# Textile Rubber & Chemical Co., Inc.

Re: Request for Changes to the Monitoring & Maintenance Plan  
Textile Rubber & Chemical Company Landfill  
HSI No. 10229  
1300 Tiarco Drive, Dalton, Georgia 30720

# **REVISED MONITORING AND MAINTENANCE PLAN**

**TEXTILE RUBBER AND CHEMICAL COMPANY  
1300 TIARCO DRIVE  
DALTON, WHITFIELD COUNTY, GEORGIA  
HSI SITE NO. 10229**

Monitoring Well Locations  
And the Landfill Cap Area

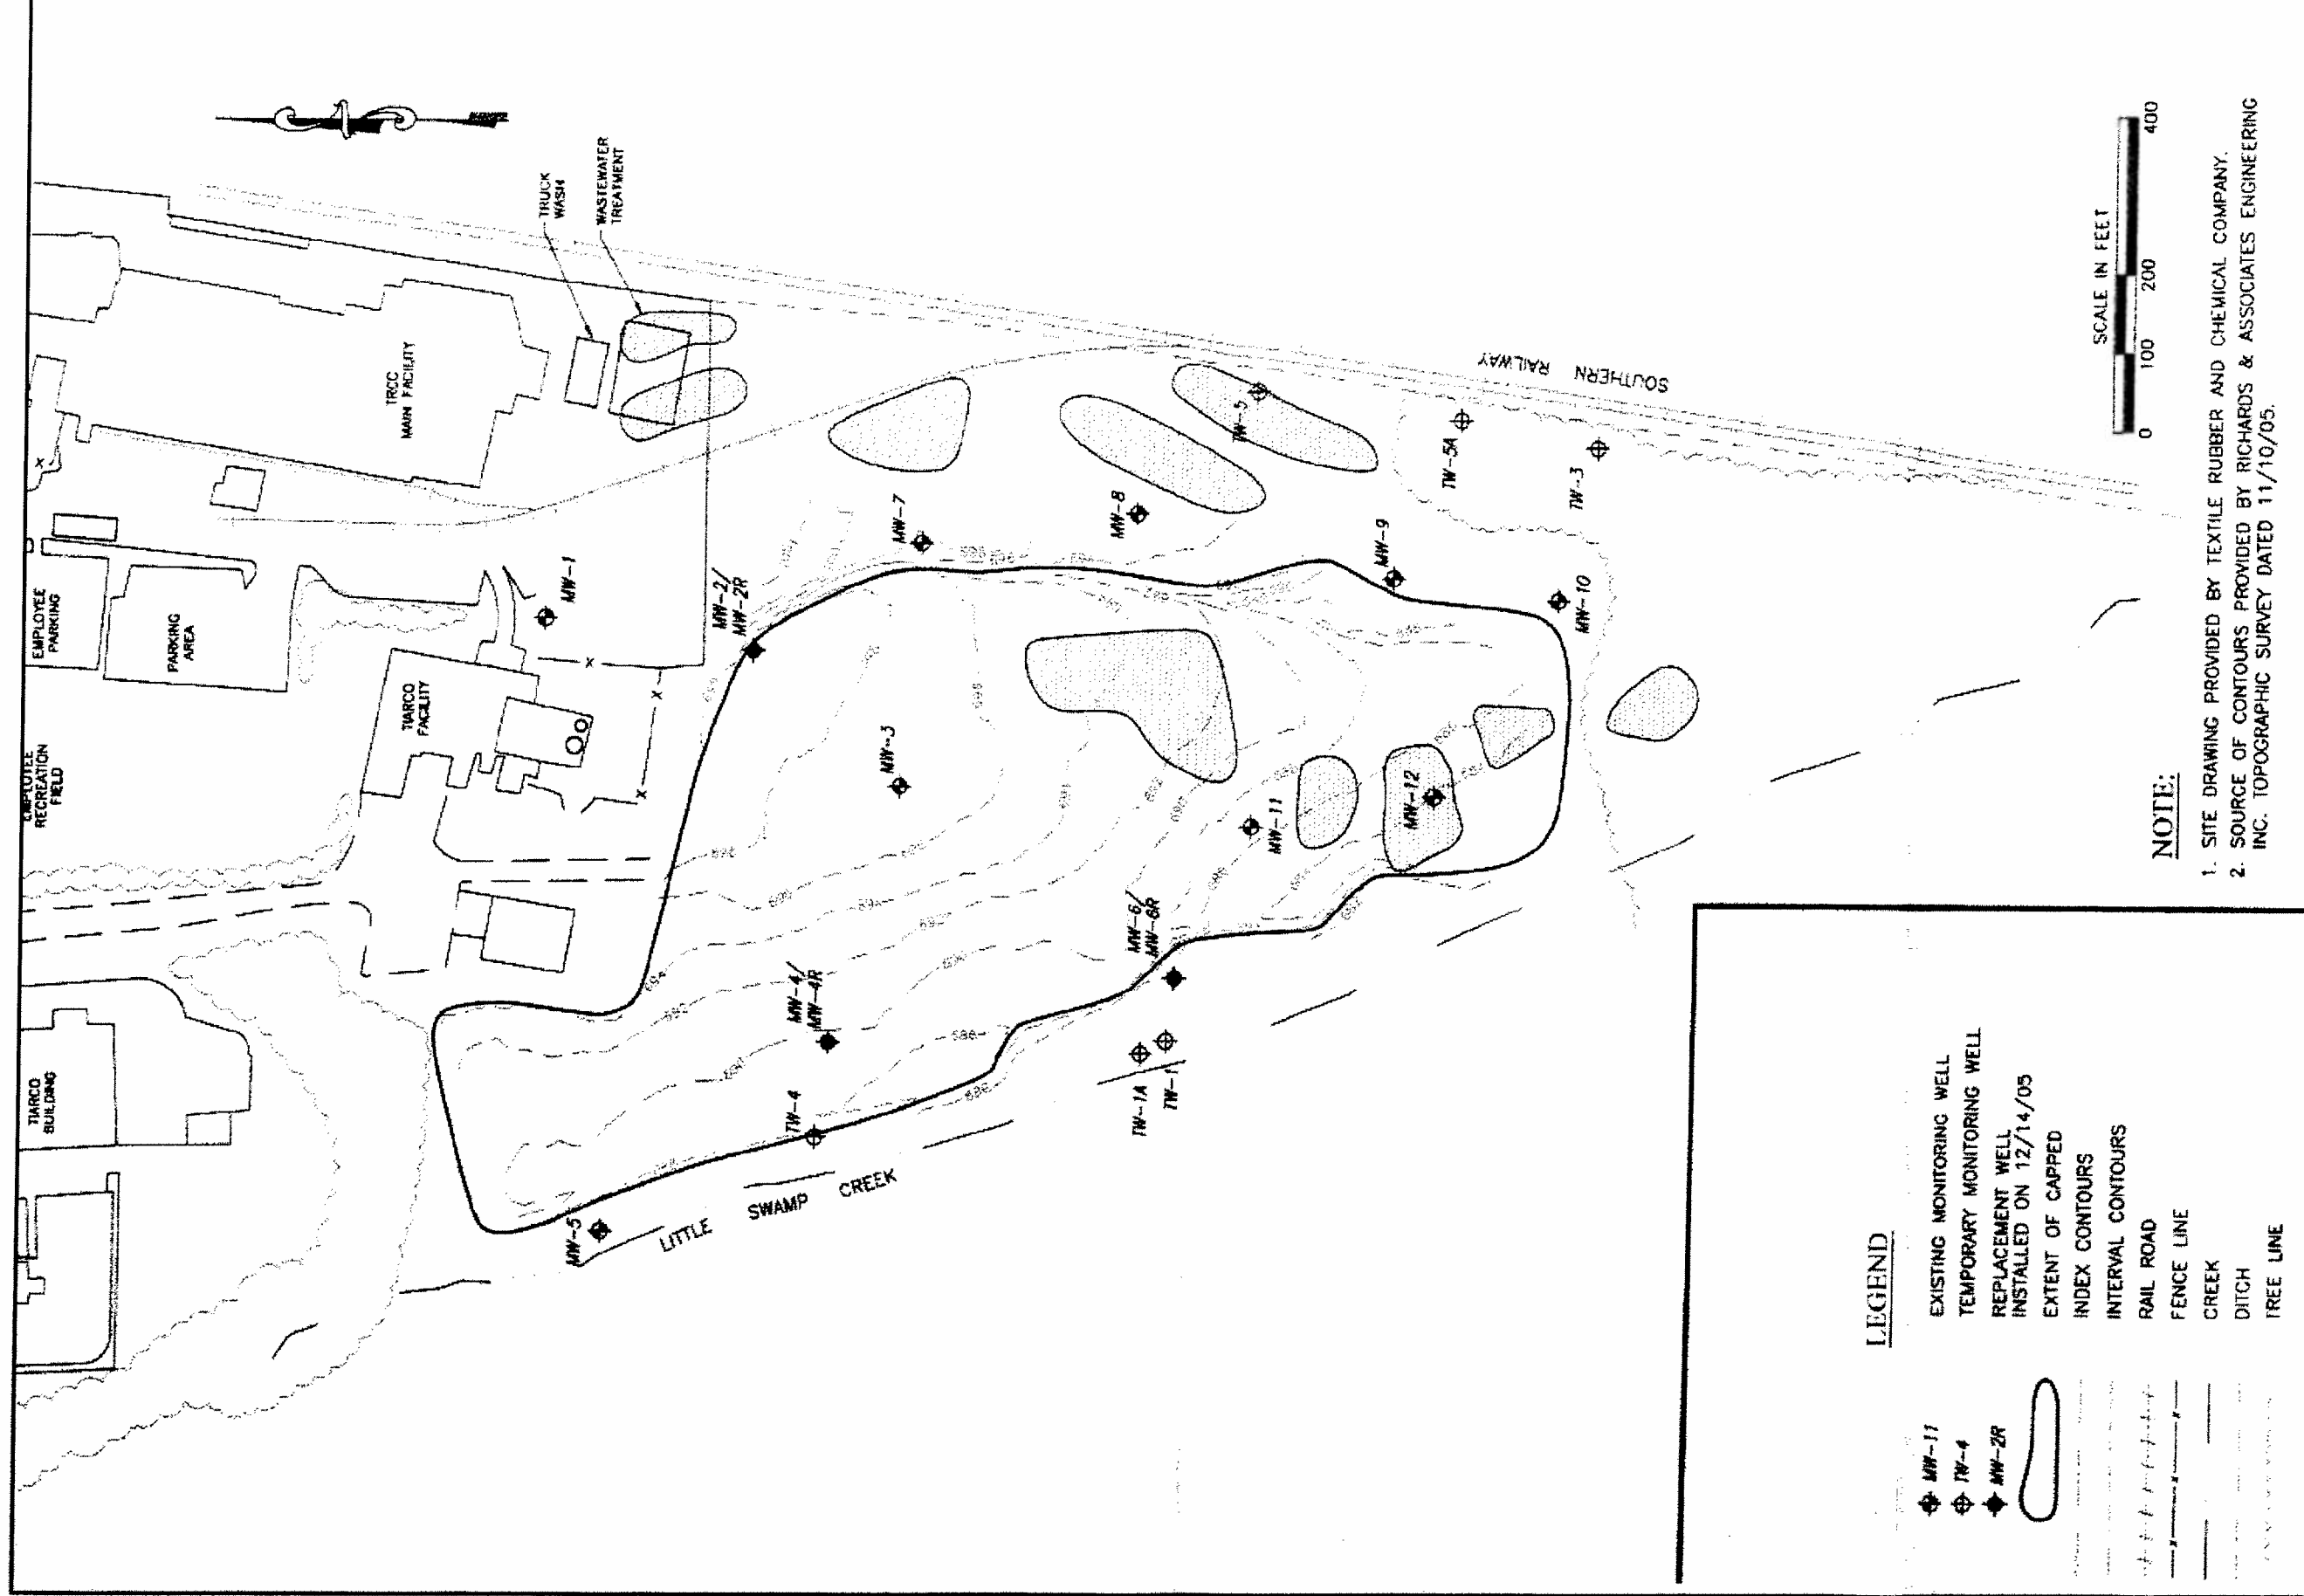
Under the October 26, 2006 M&M Plan, wells MW-4(\*), MW-5, and MW-6R are required to be sampling annually for regulated substances, and MW-1 is sampled as a background well. TRCC is proposing that sampling for MW-5 be dropped, and sampling for MW-12 be added.

This swap in monitoring wells is proposed for two reasons. First, there is no monitoring for the potential of regulated substances in the groundwater at the southern end of the Type 5 area. Second, MW-5 is located at the extreme northwestern edge of the landfill and is up-gradient and/or side-gradient of the groundwater flow for the landfill. This location means that there is very little chance of seeing groundwater issues from sampling MW-5. MW-5 has never shown any regulated substances above the groundwater Type 1 RRS. Please see the enclosed the survey and potentiometric map to verify the position of MW-5 and its unlikelihood to see groundwater contamination and to verify that MW-12 is located such that sampling will provide coverage for groundwater issues at the southern end of the Type 5 area. The enclosed potentiometric map also shows all wells and indicates those that are abandoned.

(8) Remove abandoned wells

As part of TRCC's effort in 2009 and 2010, some wells were abandoned, and these wells should be identified to no longer require depth-to-water measurements. The abandoned wells are MW-2, MW-3, and MW-4. Further, it should be clarified that when a replacement well has been installed, the original well does not need to be sampled or checked for depth-to-water measurements. These well pairings include: MW-6 and MW-6R.
